Generic Evaluation of Feedwater Transients and Small Break Loss-of-Coolant Accidents in Combustion Engineering Designed Operating Plants

Office of
Nuclear Reactor Regulation

Manuscript Completed: January 1980
Date Published: January 1980

**Bulletins and Orders Task Force
Office of Nuclear Reactor Regulation
U.S. Nuclear Regulatory Commission
Washington, D.C. 20555**

Auxiliary Feedwater System
Millstone 2
Figure 1

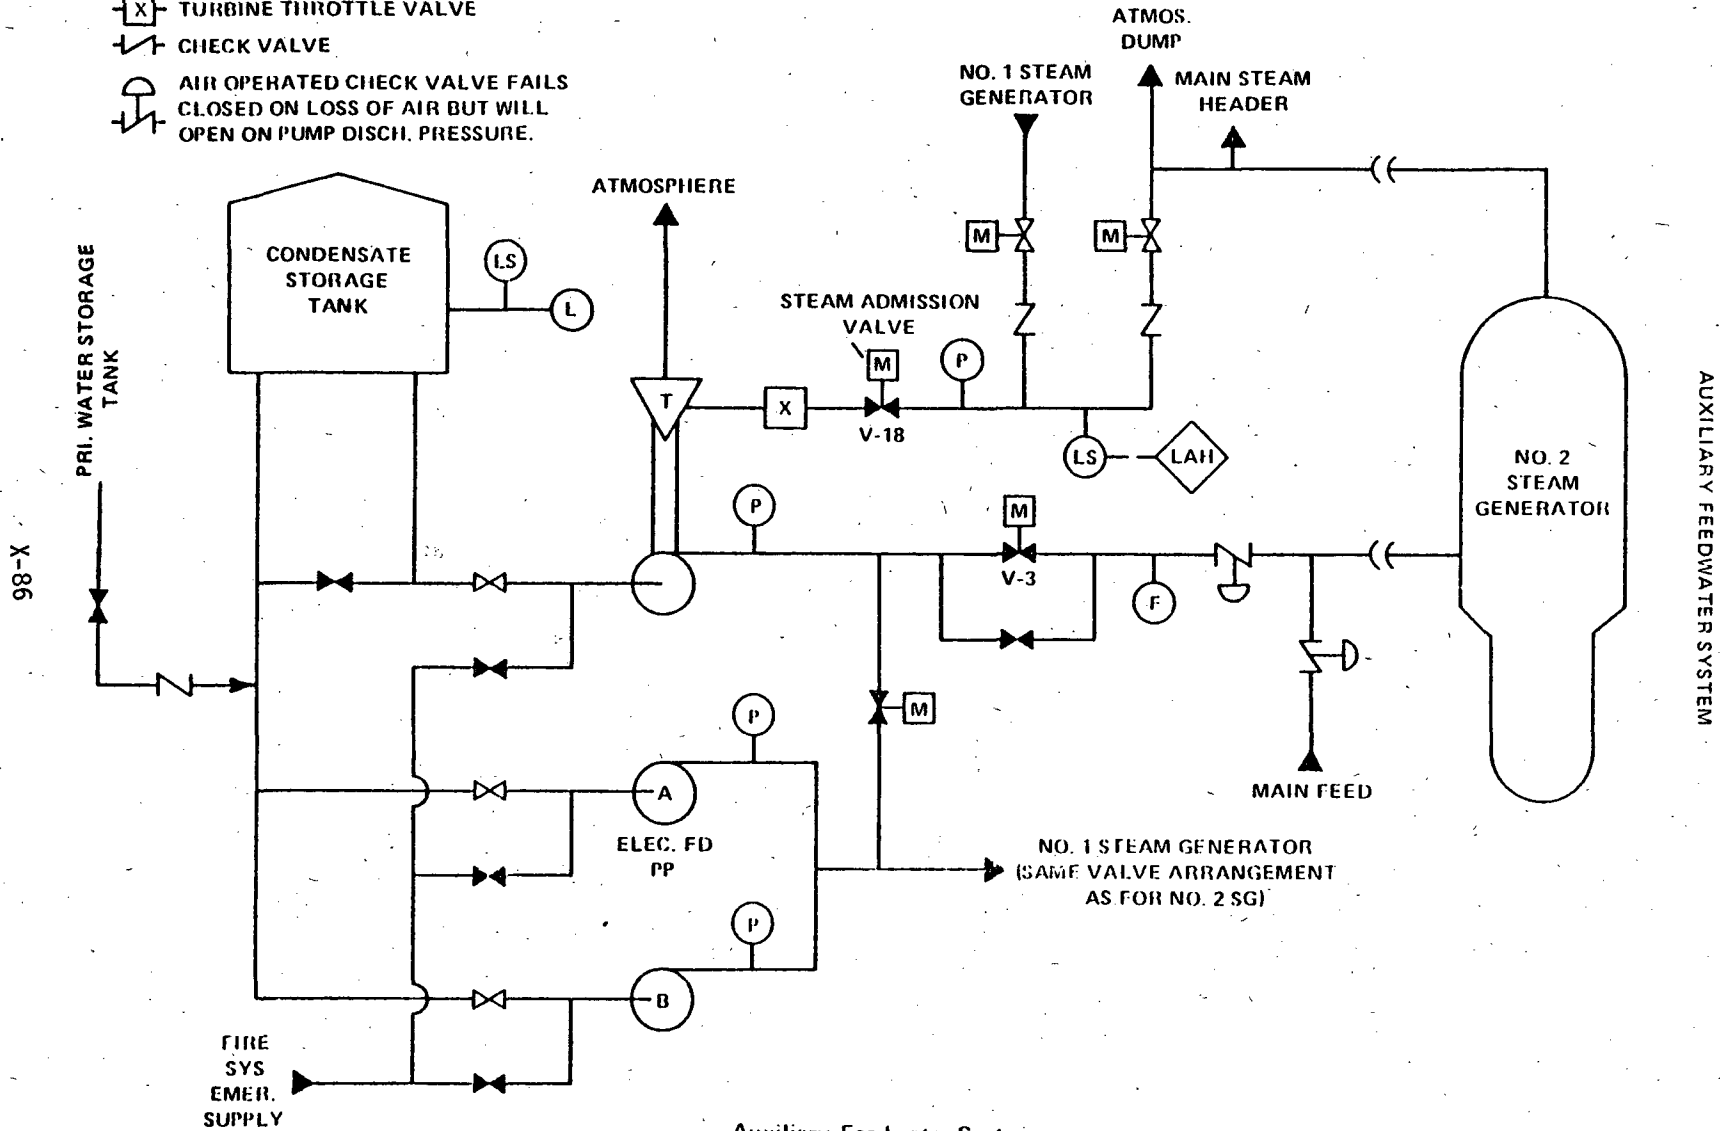
1. Recommendation - GL-1 - Licensees with plants having a manual starting AFW system should install a system to automatically initiate the AFW system flow. This system and associated automatic initiation signals should be designed and installed to meet safety-grade requirements. Manual AFW system start and control capability should be retained with manual start serving as backup to automatic AFW system initiation.

2. Recommendation - GL-3 - At least one AFW system pump and its associated flow path and essential instrumentation should automatically initiate AFW system flow and be capable of being independently of any alternating current power source for at least two hours. Conversion of direct power to alternating current is acceptable.

Auxiliary Feedwater System
Palisades
Figure 1

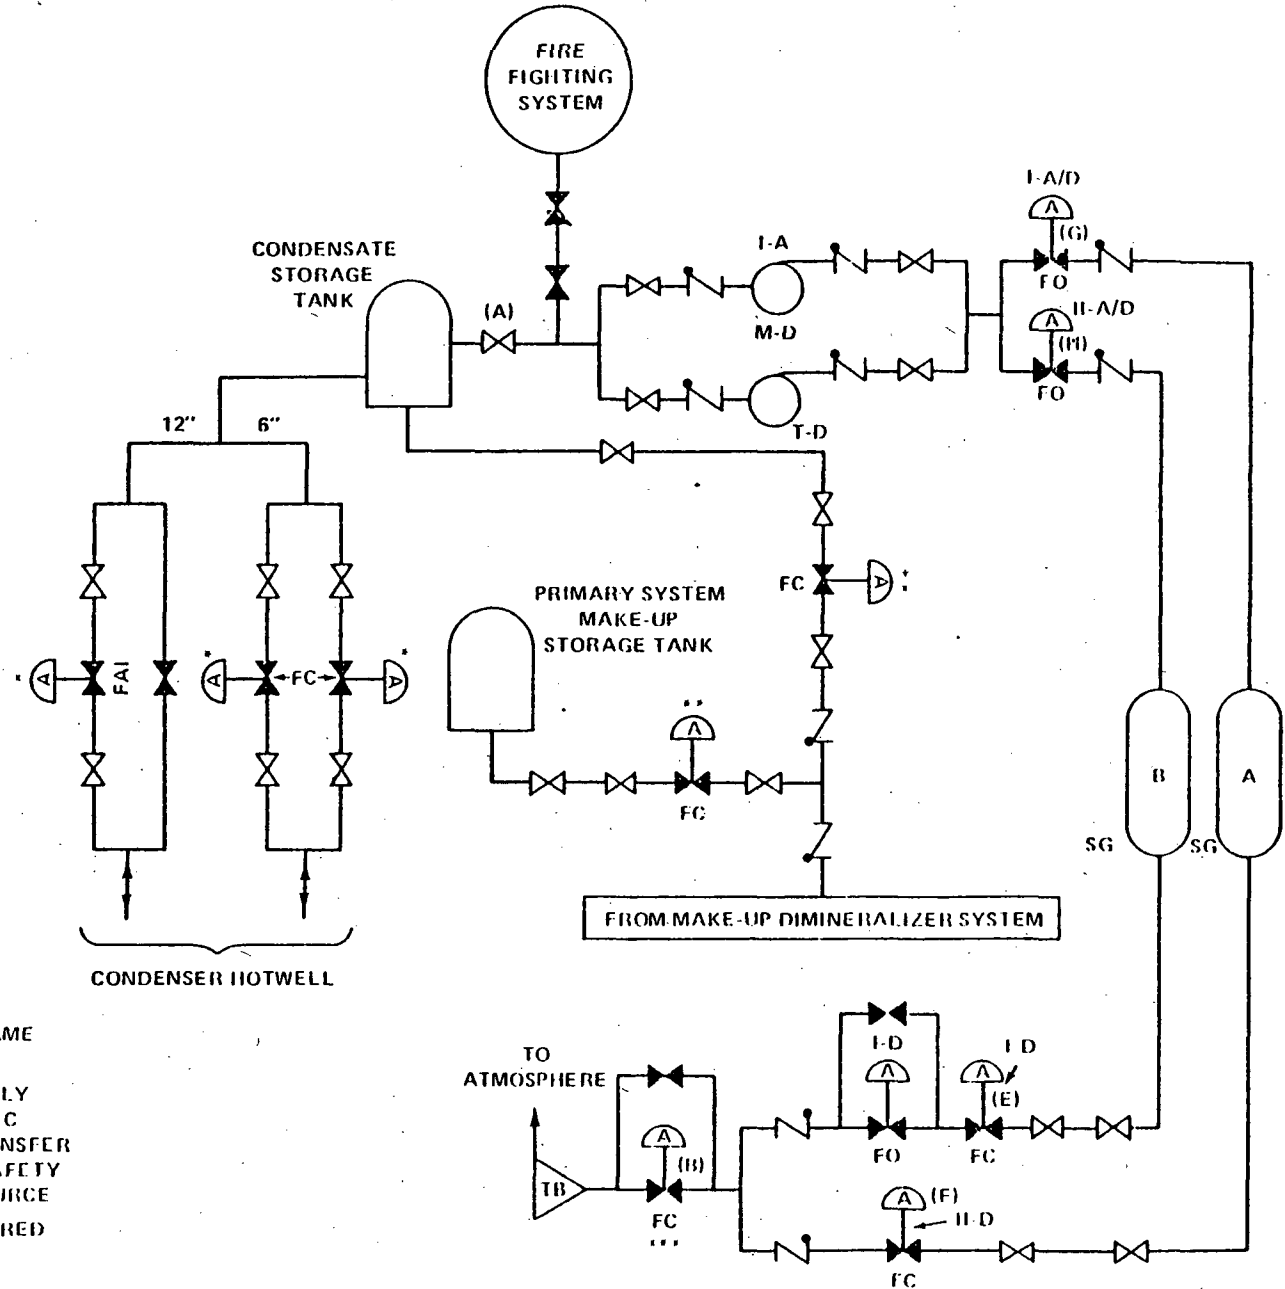
1. The Palisades Plant including the AFWS will be reevaluated during the SEP with regard to internally and externally generated missiles, pipe whip and jet impingement, quality and seismic design requirements,

earthquakes, tornadoes, floods, and the failure of nonessential systems.

2. The staff will reassess the need for a water level alarm system in the AFWS pump room.
3. The Palisades AFWS is not automatically initiated and the design does not have capability to automatically terminate feedwater flow to a depressurized steam generator and provide flow to the intact steam generator. This is accomplished by the control room operator. The effect of this provision will be assessed in the main steam line break evaluation for Palisades.
4. A lack of system redundancy exists because the turbine-driven AFWS pump is not seismic Class 1. The staff will consider the need for upgrading the seismic classification of the pump in the SEP integrated assessment of Palisades.
5. The staff will assess the need for increasing the technical specification inventory limit for the seismic Class I AFWS water supply.

Auxiliary Feedwater System
St. Lucie, Unit 1
Figure 1

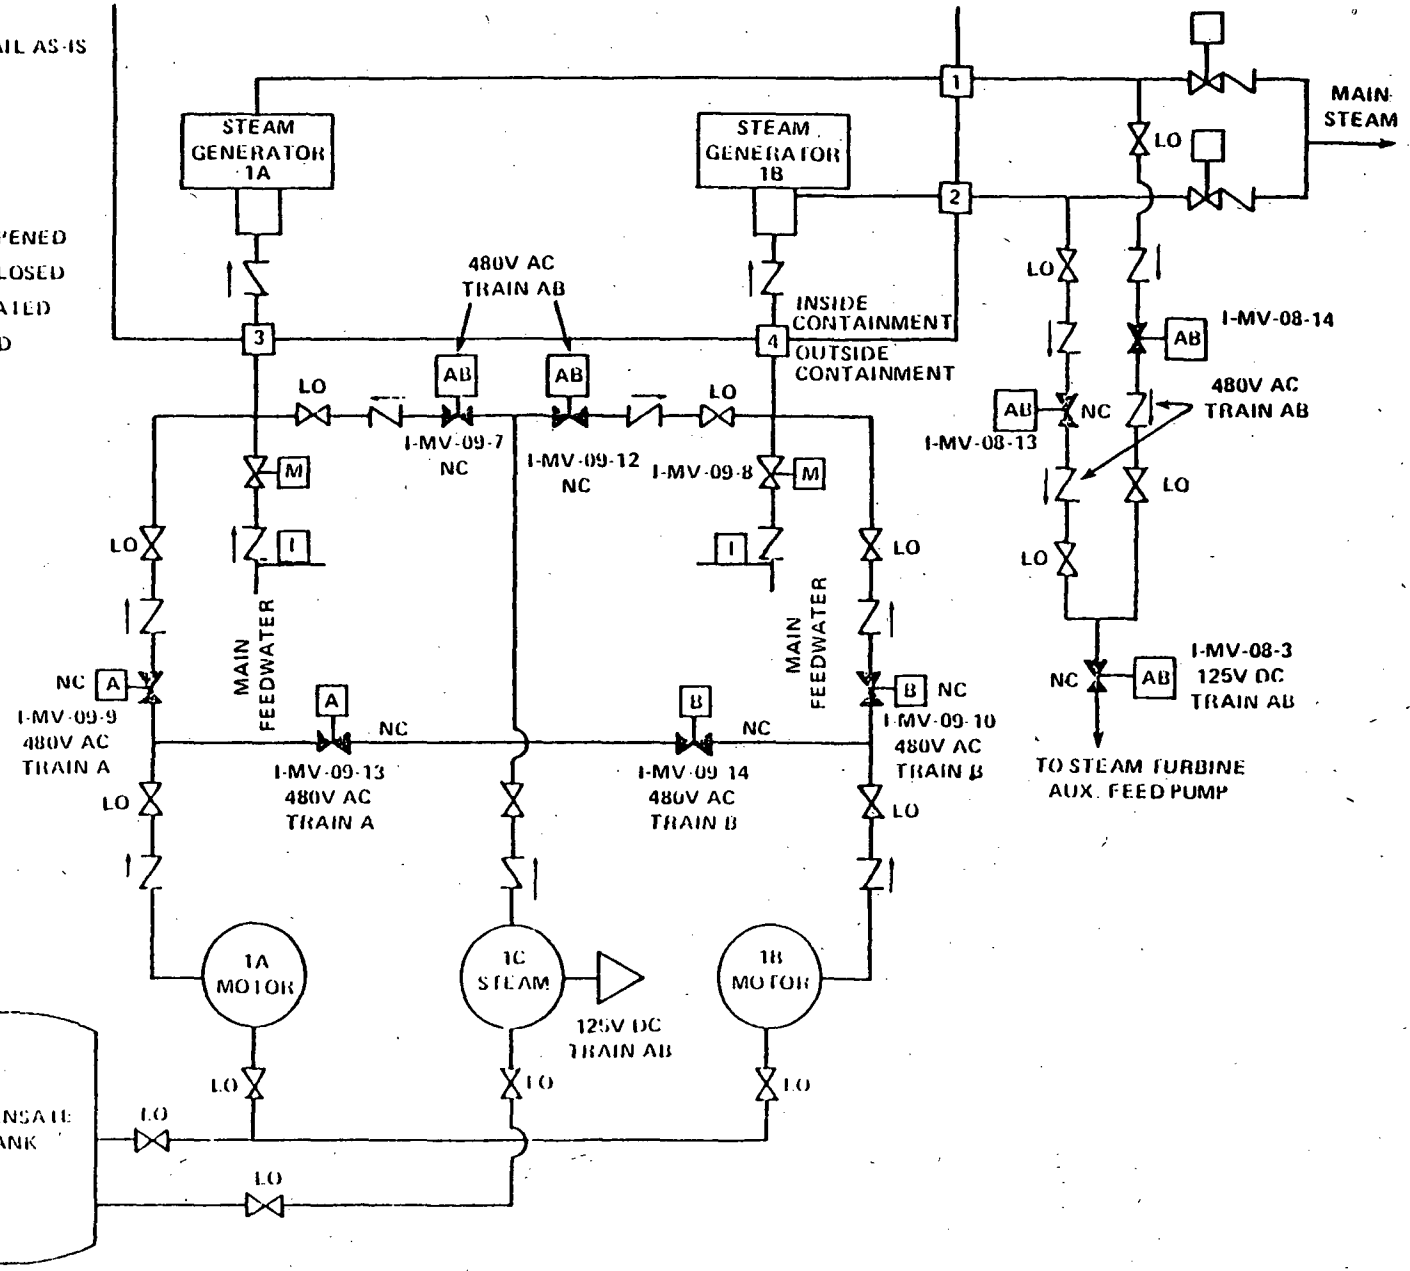
1. Recommendation - GL-1 - Licensees with plants having a manual starting AFW system, should install a system to automatically initiate the AFW system flow. This system and associated automatic initiation signals should be designed and installed to meet safety-grade requirements. Manual AFW system start and control capability should be retained with manual start serving as backup to automatic AFW system initiation.
2. Recommendation - GL-3 - At least one AFW system pump and its associated flow path and essential instrumentation should automatically initiate AFW system flow and be capable of being operated independently of any alternating current power source for at least 2 hours. Conversion of direct current power to alternating current is acceptable.

3. Recommendation - The present method of supplying water from the alternate water sources to the CST for the AFWS requires considerable operator action and is estimated to take approximately three hours to accomplish. The licensee should modify the design to provide means to supply water to the AFWS from the alternate sources within one-half hour or less.

4. Recommendation - The St. Lucie plant needs one full capacity train of AFW flow (2 motor-driven or 1 turbine-driven AFW pump) for safe plant shutdown. This AFWS design does not meet the high energy line break criteria in SRP 10.4.9 and Branch Technical Position 10-1; namely that the AFWS should maintain the capability to supply the required AFW flow to the steam generator(s) assuming a pipe break anywhere in the AFW pump discharge lines plus a single active failure. The licensee should (1) complete an evaluation assuming such an event and determine any AFW system modifications or procedures necessary to maintain the required AFW flow to the steam generator(s), or (2) describe how the plant can be brought to a safe shutdown condition by use of other available systems following such a postulated event.
